June 5, 2014

Mr. Harinder Singh,  
California Energy Commission,  
Dockets Office, MS-4,  
Re: Docket No. 14-AAER-1,  
1516 Ninth Street,  
Sacramento, CA 95814-5512

Subject: MaP® Issues – CEC Docket No. 14-AAER-1, Appliance Efficiency Pre-Rulemaking

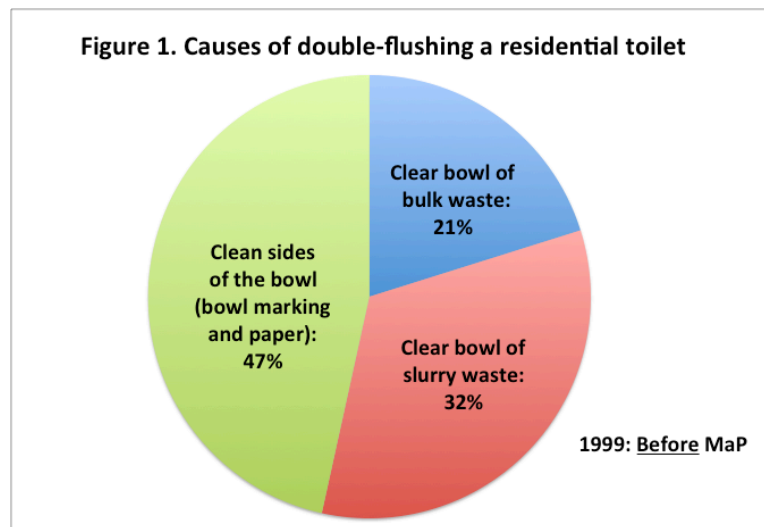
Based upon the findings of a 1999 customer satisfaction study undertaken by the Metropolitan Water District of Southern California<sup>7</sup>, the frequency of each of these causes of double flushing can be identified as shown in Figure 1.

It should be noted that the 1999 study was conducted before the development of MaP® and the resulting improvements in bulk waste removal.

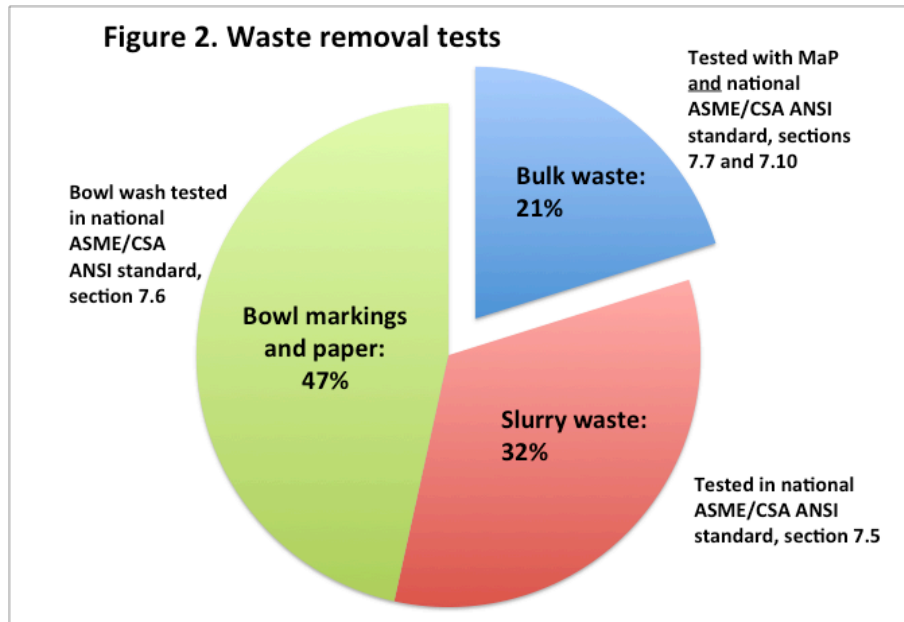
The current national standard (ASME A112.19.2-2013/CSA B45.1-13) contains specific test protocols for all four potential causes of double flushing, and establishes minimum performance requirements for each. MaP tests for bulk waste removal only. Table 1 and Figure 2 display the distribution of the four causes and the applicable test elements of the national standard.

Not only will increasing the minimum requirement to 600 grams not address the double flushing issues associated with items 2, 3, and 4 in Table 1, but it could actually make those issues worse as manufacturers could be driven to divert more water away from rim punchings (which direct water to help clean the sides of the bowl) to ensure increased bulk removal capability. As a result, not only would double flushing not be reduced, it is possible, perhaps even likely, that it would increase as less water is made available to clean the sides of the bowl.

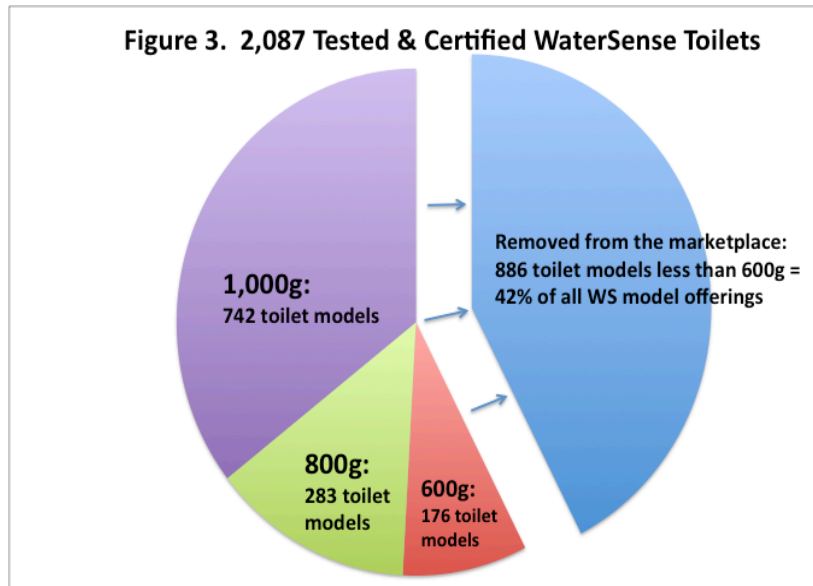
As of May 2014, a total of 2,087 individual toilet models were certified to the WaterSense® specification. Of these 2,087 models, 886 (42 percent) had not been shown to achieve a 600 gram MaP® threshold. Many (but not all) of these 886 models rely solely upon the minimum 350 gram WaterSense® requirement for a marketplace presence. Yet, these very same WaterSense® products compete successfully in the marketplace and meet consumer expectations. If implemented today, the 600 gram threshold would unfairly remove 886 qualified products from the California marketplace, significantly and adversely impacting consumer choice and likely cost<sup>8</sup>. See Figure 3.
